No. 273
Date: 12.03.2019

Improved MT5 Center Body Pin

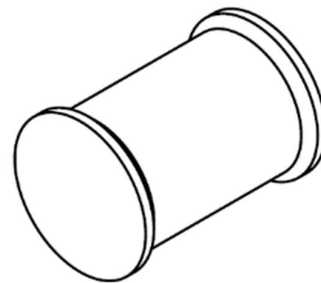
We would like to update you on recent change related to our MT5 center body pin. The center body pin for MT5 key system modified into Spool shape in the last chamber in order to better protect last chamber and provide higher resistance against manipulation attempt using counterfeit keys.

This new version pin will soon be in use and will not be reflected by **changes** in any of the part numbers related to this pin. Only version changed.

You can use old version pin whether you have it in your stock, until stock ends.
